**From:** Poslusny, Chester [cposlusny@babcock.com]  
**Sent:** Friday, March 25, 2011 6:26 AM  
**To:** Starefos, Joelle  
**Cc:** Arnholt, Brian K; Childerson, Michael T  
**Subject:** I&C Responses to Comments  
**Attachments:** B&W Response to NRC Questions on Instrument Setpoint Methodology\_3\_24\_2011-1.pdf

**B&W Review and response to NRC Questions raised during the acceptance review for the B&W Instrument Setpoint Methodology Topical Report (R0003-08-002089).**

UNVERIFIED DRAFT  
Proposed revision to Figure 5.1 in B&W Instrument Setpoint Topical Report

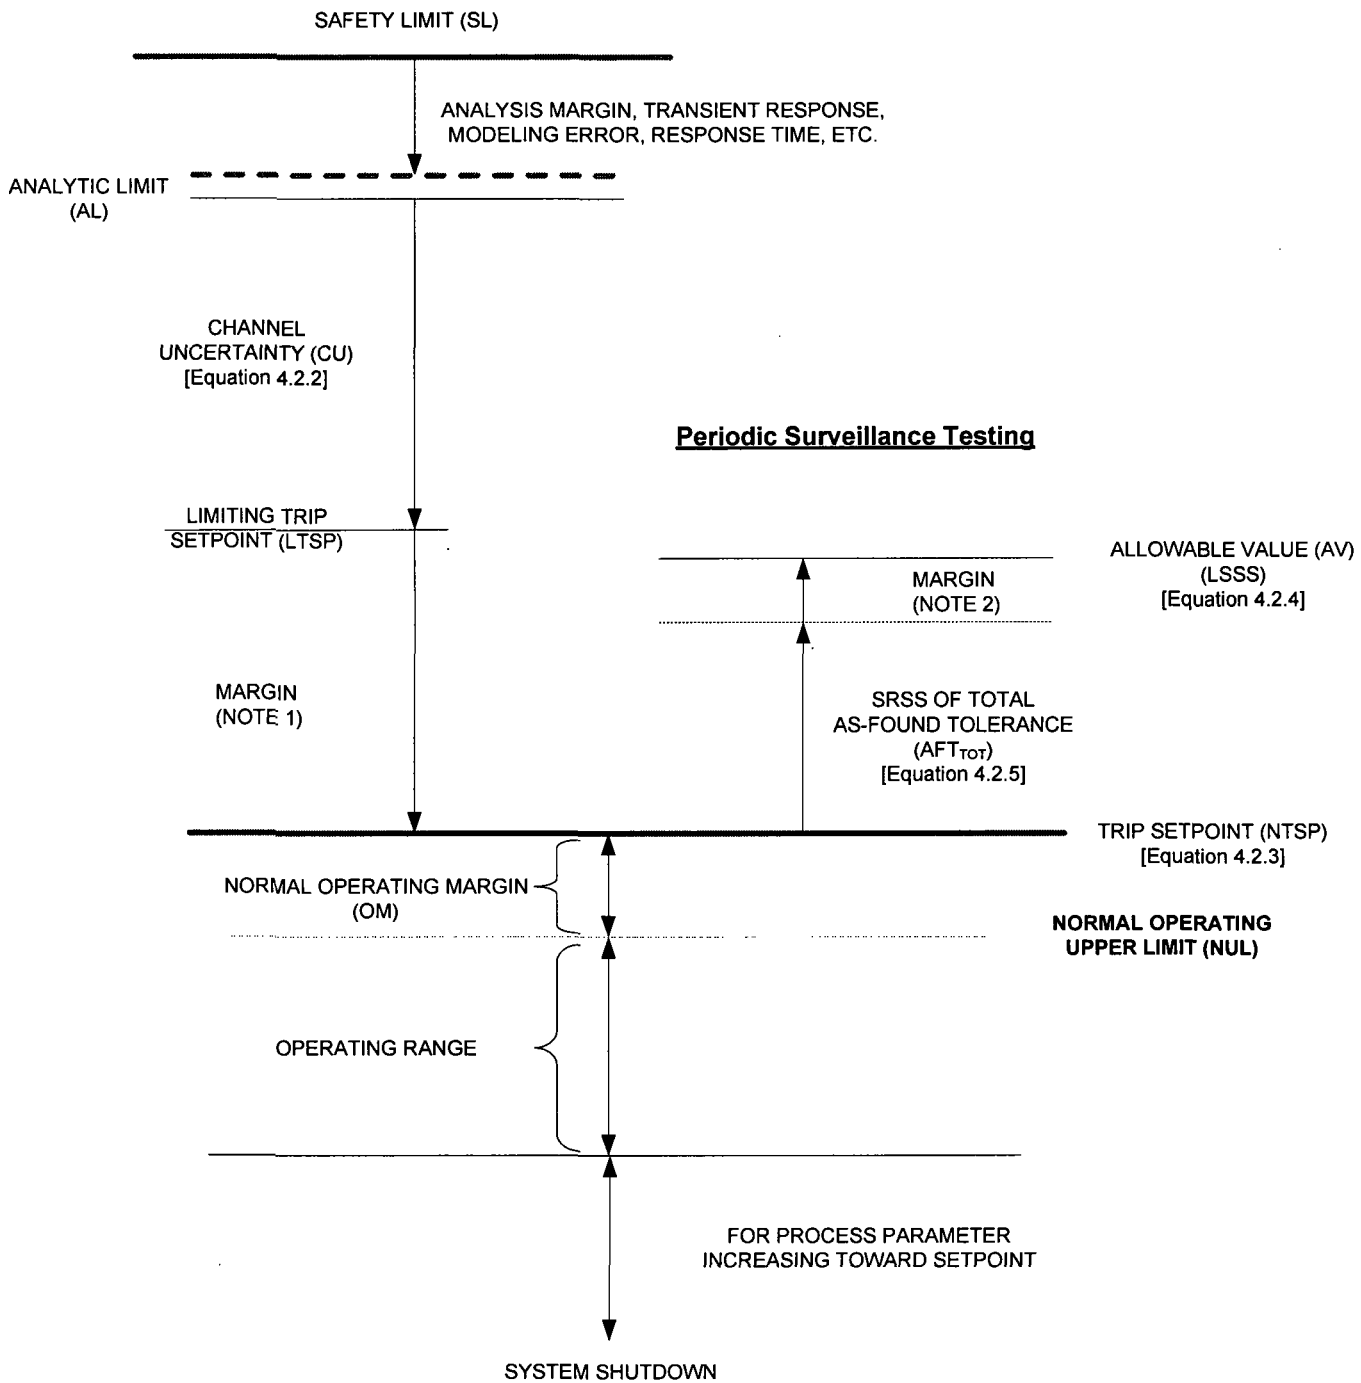
The NRC staff indicated that their fundamental issue is related to the discussion contained in question 1 which identified a potential discrepancy between equations 4.2.3 and 4.2.4 and the illustrations in Figure 5.1.

From its understanding of the NRC's concerns, B&W understands the NRC is concerned that while the equations (4.2.2, 4.2.3, and 4.2.4) use the SRSS method to combine errors to calculate the values for CU, NTSP and AV, respectively, it was understood by the reviewers that Figure 5.1 represented that the errors for these same terms was combined algebraically, which presents a potential inconsistency. Additionally, the NRC stated that the AFT should center around the NTSP, and not from the AV.

- Discrepancy between Figure 5.1 versus Equations (methodology) in 4.2.2-4.2.4

The methodology uses square-root-summation-of-squares (SRSS) technique to combine instrument loop uncertainties which are statistically and functionally independent and random. Channel Uncertainty (CU) is calculated by SRSS of all instrument channel independent uncertainties from analytical limit (AL) including those uncertainties not measured during the surveillance tests. Methodology and figure should have same expressions/equations for each section identified. For example, AFT should be around NTSP not from AV. In addition, ALT should be included in the figure.

In Figure 5.1, Margin (Note 1) and Margin (Note 2) appear to be the same. Are they always the same? It is not clear how they are determined.

LSSS should be clearly identified in both methodology and Figure 5.1.

Specific factors should be identified instead of using ETC or etc.

Figure 5.1 was intended to be a notional representation of the relationships between the NTSP, CU, and AV and represent how these are used to ensure the instrument channel setpoints are established and ensured to protect the safety limit (SL). It was not intended to illustrate the methodology for combining errors in the various components that make up the terms for CU, AV, and NTSP; the equations presented in the report show the methodology used for combining errors. This approach is consistent with the guidance contained in ISA-S67.04.01-2000 where Figure 1 is a notional representation of the relationship between instrument channel setpoints and does not attempt to show the methods for combining errors.

B&W recognizes that there may be ambiguity with Figure 5.1 that could lead the reviewers to identify an inconsistency between the equations and figures, and a proposed revision is provided for review that clearly delineates the setpoint relationships safety and design basis, and during periodic surveillance and calibration.

To alleviate these concerns and add clarity to address the NRC questions, B&W proposes to revise Figure 5.1 to show a distinction between the safety analysis and design bases for the limiting safety system setting (LSSS). This clarification shows that the LSSS is applied to the allowable value which ensures the safety limit is satisfied; since the AV is less than the LTSP. This is consistent with RIS 2006-17 that concludes "the LTSP protects the Safety Limit."

The proposed revision to Figure 5.1 shows two representations of how the various setpoint parameters relate to the safety analysis and design basis and the relation to periodic surveillance testing to demonstrate channel operability. The AV is the minimum acceptable as-found value for the trip setpoint (with margin applied for conservatism), in which the instrument channel is still considered operable. This ensures that the AL and safety limit are protected during periodic surveillance. In this revision, the NTSP is now shown to be determined from the AL by accounting for the total channel uncertainty and margin (if applicable).

- NOTES:
1. THERE IS NO SET VALUE FOR MARGIN. IT IS A DISCRETIONARY VALUE BASED ON ENGINEERING JUDGEMENT TO ADD CONSERVATISM TO THE CU, TO ENSURE THE TRIP SETPOINT PROTECTS THE ANALYTIC LIMIT.
  2. DURING SURVEILLANCE TESTING, IF MARGIN IS ADDED BETWEEN THE TRIP SETPOINT AND AV, THE AS-FOUND TOLERANCE IS TO BE USED TO IDENTIFY IF THE INSTRUMENT IS DEGRADED.
